Bornish Wind Energy Centre Comparative Layout - Southwest

Bornish Wind Energy Centre Comparative Layout - T-Line

4.0 Amendments to the Records Review

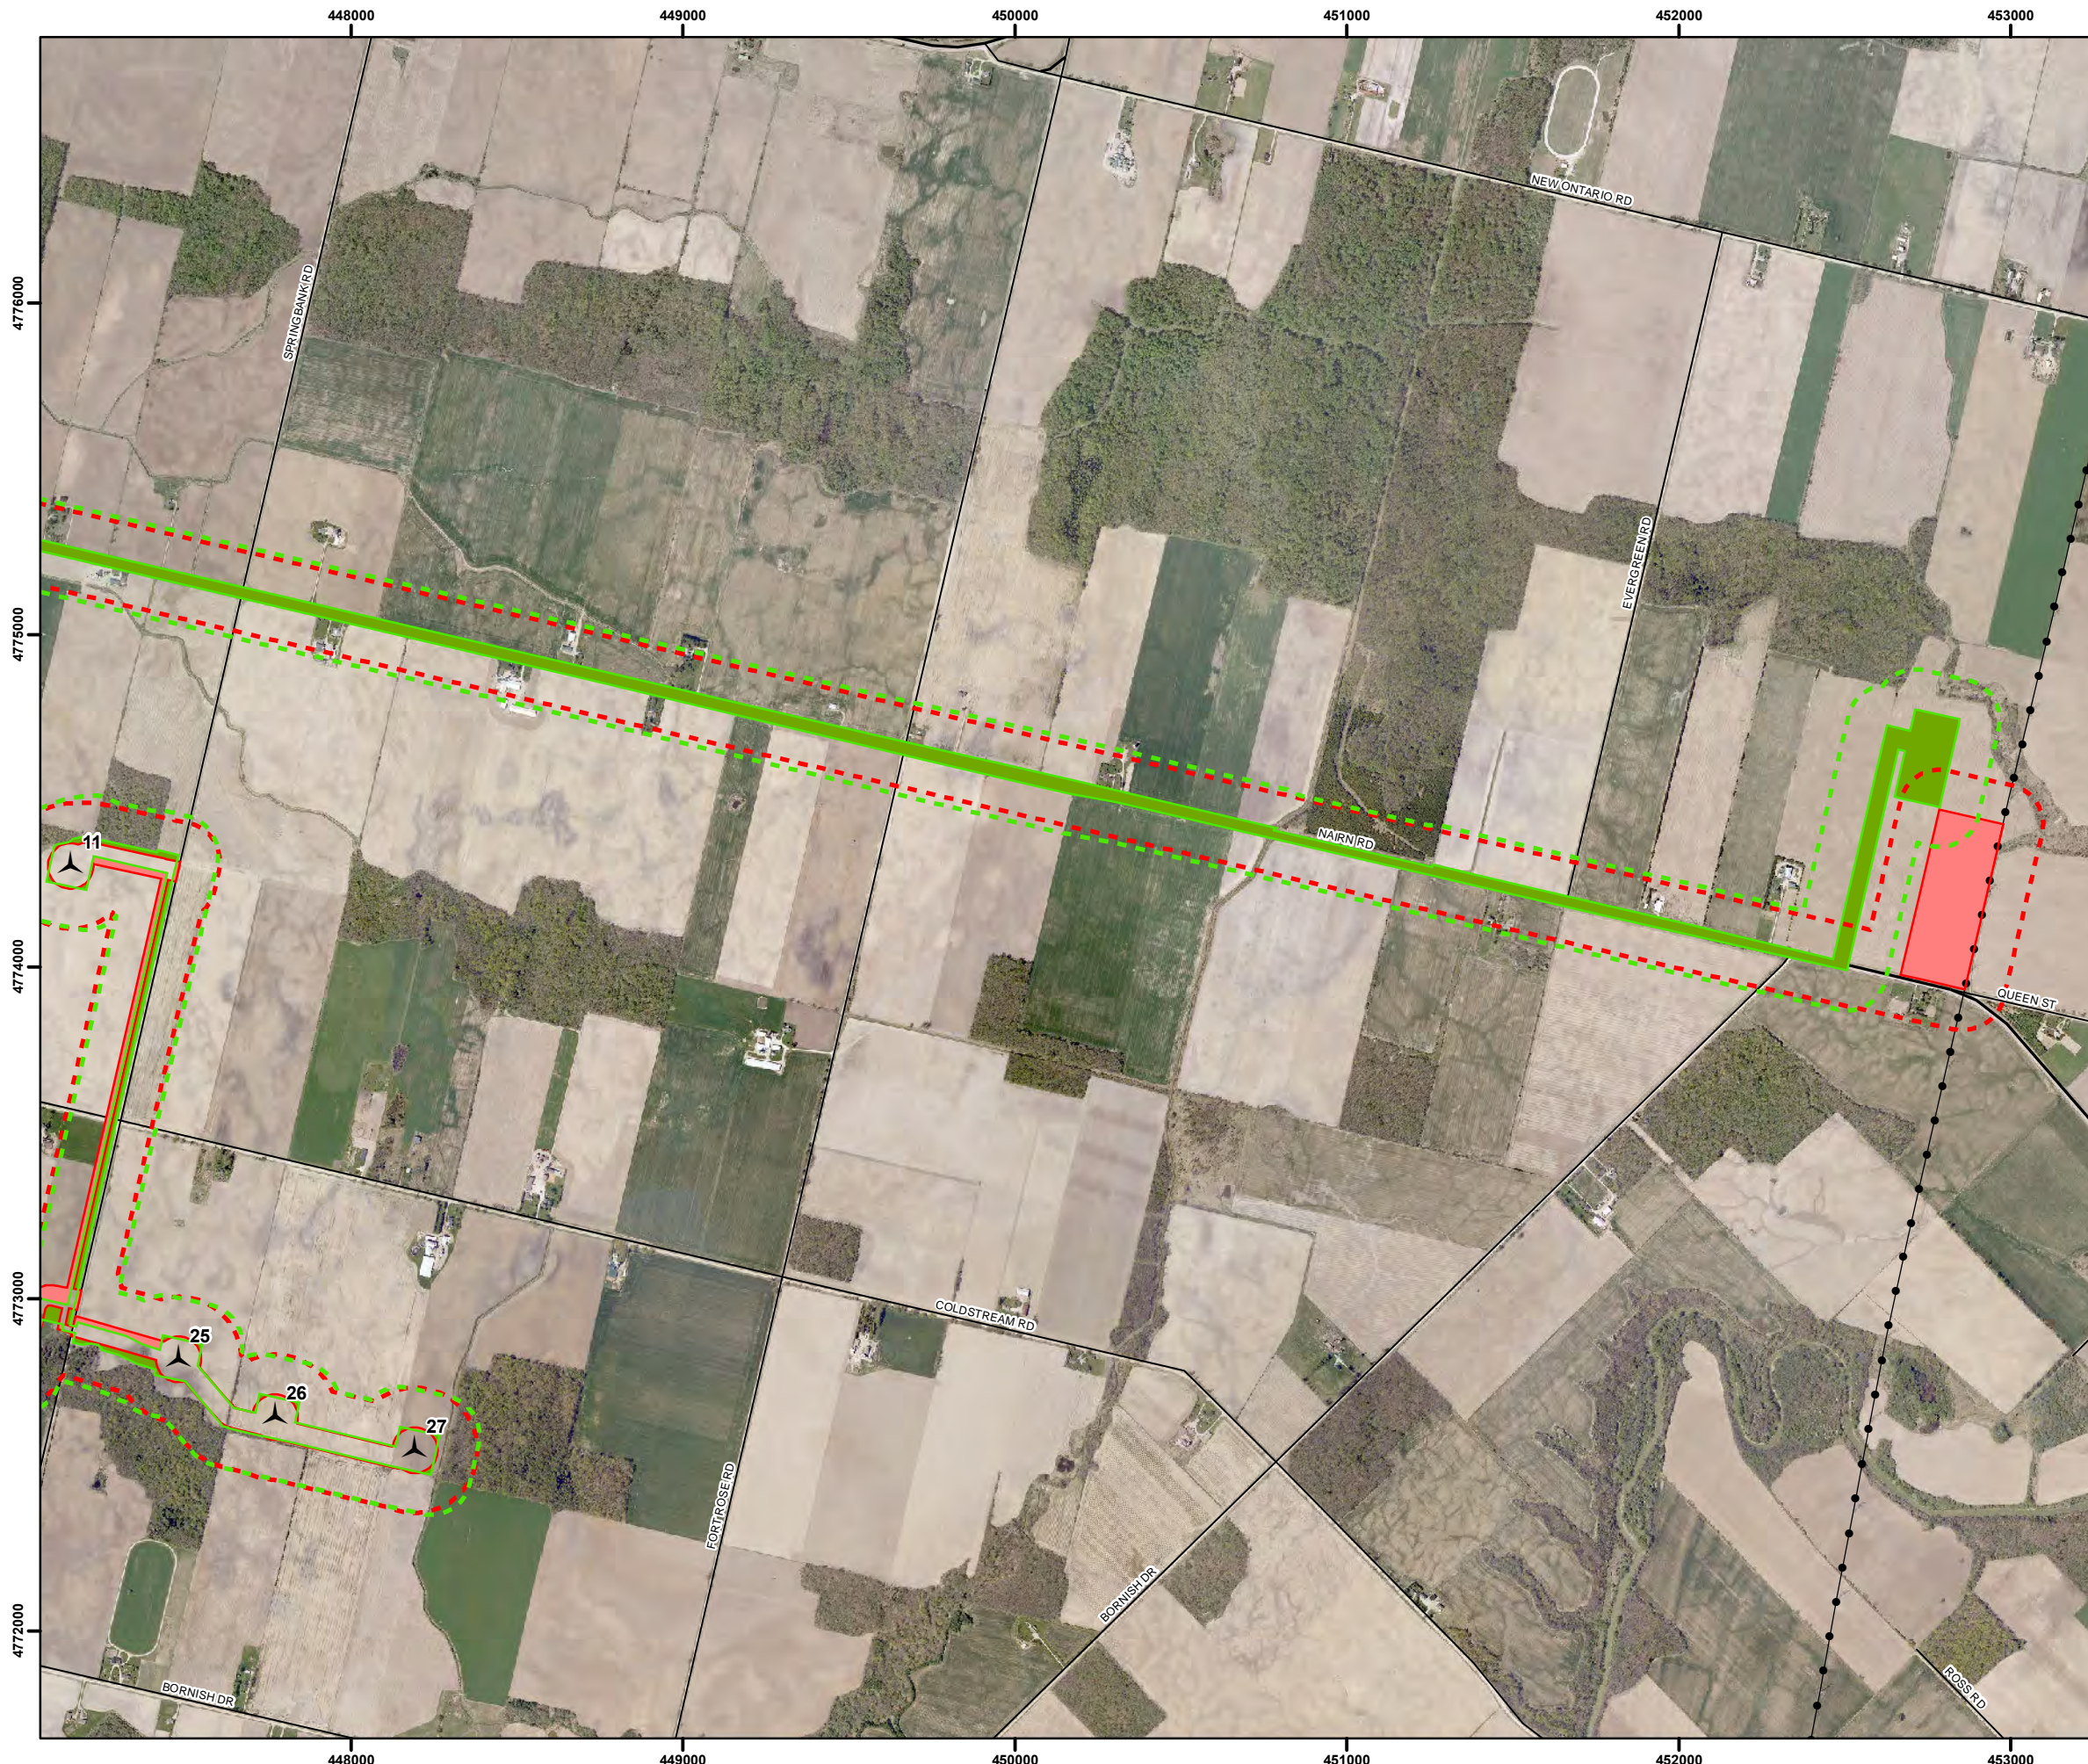
Given the changes in project location, described and mapped above, NRSI has identified that there are several instances where the project location is now closer to natural features that had been identified as being within 120m of the project location. Each of these specific instances has been outlined below (Table 2), including feature identification number, feature type, and comparison of distances from project location to natural feature between the presented layouts.
